# SERVICE BULLETIN REVISION NOTICE

NON-MODIFICATION SERVICE BULLETIN — ENGINE — CONTROL RODS, ASSEMBLY OF —  
PROVIDE AN EDDY CURRENT INSPECTION (ECI) TO IDENTIFY ANY NON-CONFORMING  
MATERIAL WITHIN THE CONTROL RODS

Turbojet Engine Service Bulletin No. V2500-ENG-72-0703 Revision No. 1 dated June 27, 2019.

# V2500-ENG-72-0703

INSPECTION ZONES, TWO PER CONTROL ROD END  
FIGURE 1

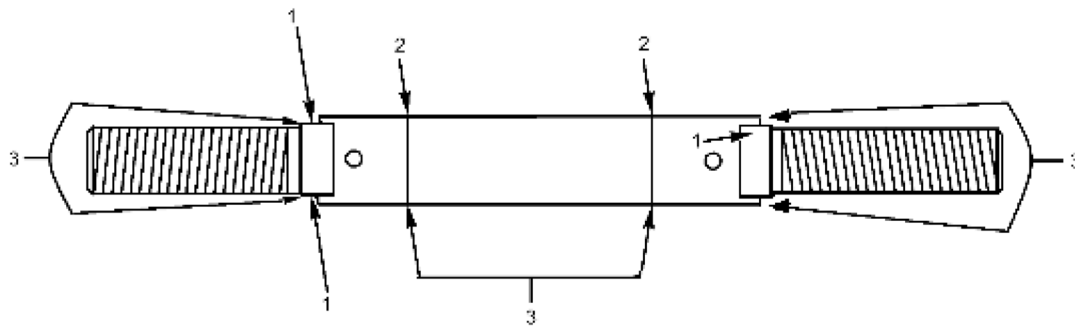
To remove the requirement to ECI the center of the control rod from the Accomplishment Instructions.

- A. The inspection zones are the flats on both ends of the control rod(s), up to the weld lines. Refer to Figure 1.

**WARNING:** DO NOT COLLECT DATA FROM THE THREADED OR REDUCED DIAMETER PORTION OF THE CONTROL RODS. DATA COLLECTION FROM OTHER LOCATIONS COULD RESULT IN ERRATIC ECI RESPONSE.
